Access Compliance Report

Public Rights-of-Way

Intersection ID: N/A	Main Street: AGNEW_DR	Cross Street: COWGILL_LN	Location: NE
ADA ID: C6955997FD1C	Ramp Type: Perp	Initial Pass/Fail: Fail	Overall Compliance: No
Codes/Mitigation Info/Possible Solution		Field Measurements/Component Compliance

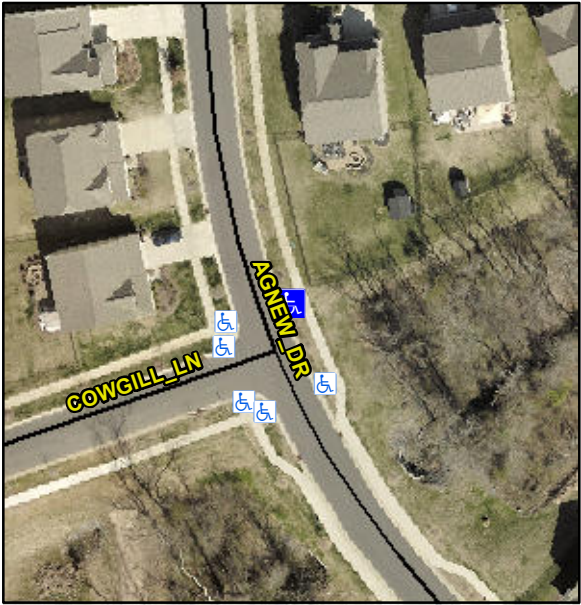
Possible Solutions:						
	Remove & Replace Entire Ramp.	N/A	Ramp Length (in)	96.0	Yes	Ramp Slope (%)	5.9
		No	Ramp Width (in)	46.5	No	Ramp XSlope (%)	2.9
		N/A	Flare Type LT	N/A	N/A	Flare Type RT	N/A
		N/A	Flare Slope LT (%)	N/A	N/A	Flare Slope RT (%)	N/A
		N/A	Flare Traversable LT?	N/A	N/A	Flare Traversable RT?	N/A
		N/A	Landing Length (in)	N/A	N/A	DWS Provided?	N/A
		N/A	Landing Width (in)	N/A	N/A	DWS Contrast?	N/A
		N/A	Landing Slope (%)	N/A	N/A	DWS Length (in)	N/A
		N/A	Landing X Slope (%)	N/A	N/A	DWS Full Width?	N/A
		N/A	Landing Curb? (Y/N)	N/A	N/A	DWS Offset (in)	N/A
		N/A	Shared Landing?	N/A			
		N/A	Gutter Ponding?	N/A	N/A	Gutter Slope (%)	N/A
		N/A	Gutter Lip Ht (in)	N/A	N/A	Gutter X Slope (%)	N/A
		N/A	Painted X Walk1?	No	N/A	Painted X Walk2?	N/A
			X Walk 1 Direction	To W		X Walk 2 Direction	N/A
		N/A	X Walk 1 Width (in)	N/A	N/A	X Walk 2 Width (in)	N/A
			X Walk 1 Slope (%)	2.7		X Walk 2 Slope (%)	N/A

X Walk 1 X Slope (%)	2.4		X Walk 2 X Slope (%)	N/A
		N/A	Ramp inside XWalk1?	N/A	N/A	Ramp inside XWalk2?	N/A
<p>Surveyor Notes:</p> <p>N/A</p> <p>PROW/ADA:</p> <p>Not Found, R304.5.1, R304.5.3</p>		N/A	Road Slope (%)	N/A	N/A	Clear Space?	N/A
		N/A	Road X Slope (%)	N/A	N/A	Clear Space to XWalk (in)	N/A
Total Cost:		\$	1850.00		N/A	Storm Grate/Utility Hazard?	N/A
			Obstruction Type			Storm Grate/Utility Type	
					N/A		N/A
					Yes	Surface Condition? (G/P)	Good
